Access Compliance Report

Public Rights-of-Way

(Pedestrian Signals)

Intersection ID: N/A	Main Street:	Cross Street: N/A	Location: N/A
ADA ID: 502869FEC631	Signal Type: Two Push Buttons-Non APS	Overall Compliance: No	Severity Score: BTN 1:N/A BTN 2: N/A No BTN: N/A
Codes/Mitigation Info/Possible Solution		Field Measurements/Component Compliance

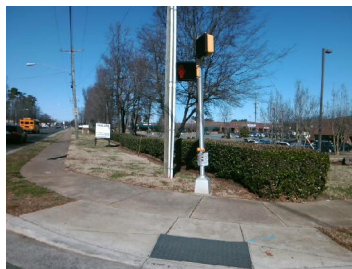
PROW/ADA: TMUTCD 4e.08, R404.2, R404.7.2

Possible Solutions: Replace Signal Push Button With APS Button on New Post. Remove & Relocate Sign.
